# Mobile Intel<sup>®</sup> Pentium<sup>®</sup> 4 Processor-M and Intel<sup>®</sup> 852GM Chipset Platform

Design Guide Update

*April 2005*

Document Number: **305341-002**

## 1. Correction on Buffer Pinout/Connection for CRT VSYNC/HSYNC

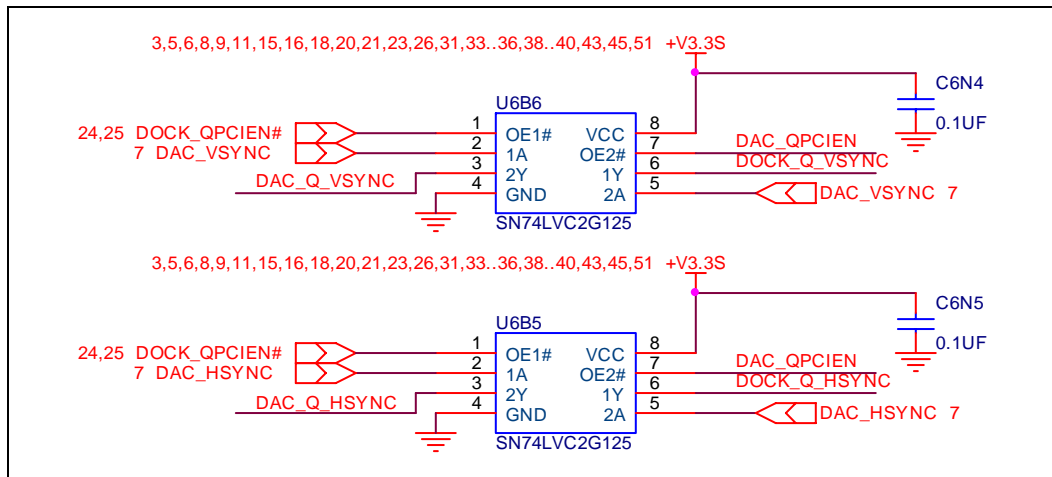
Schematics net connections for CRT VSYNC/HSYNC to onboard VGA connector and docking connector via SN74LVC2G125 should be corrected as follows (schematics sheet 17).

## 2. Correction on Pinout/Connection for Processor Power

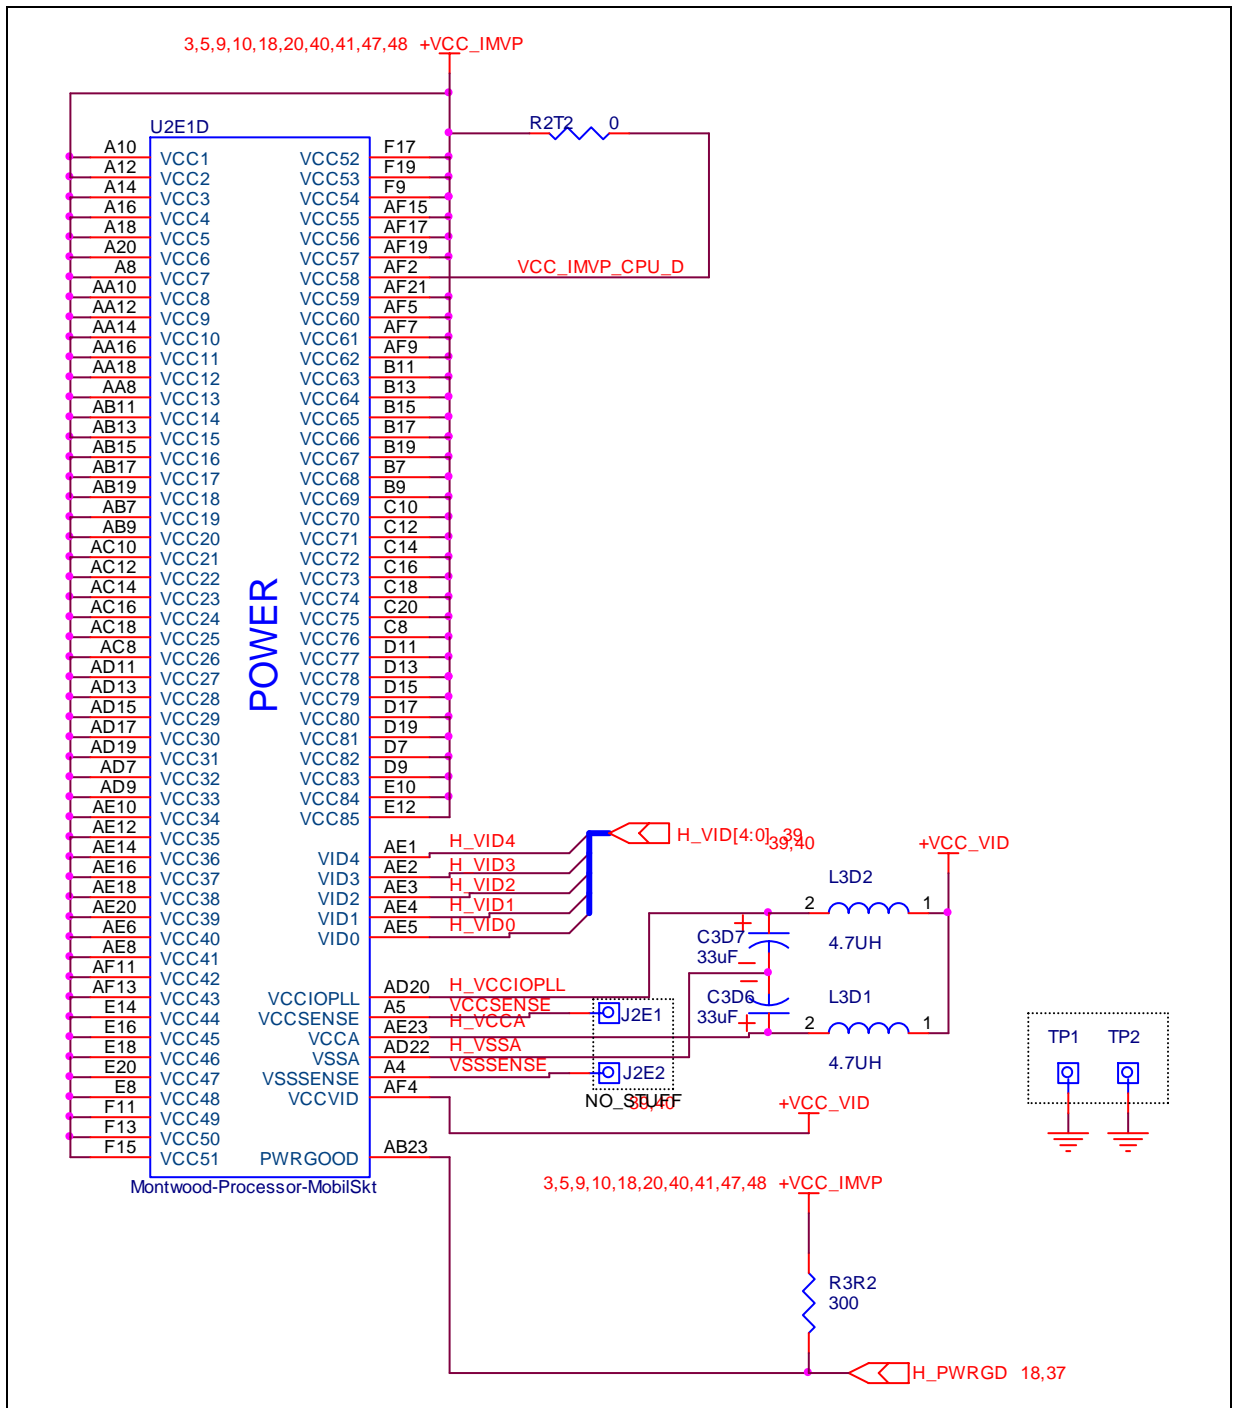
Schematics net connections for VCCA and VCCIOPLL for the Processor power should be corrected as follows (schematics sheet 4).
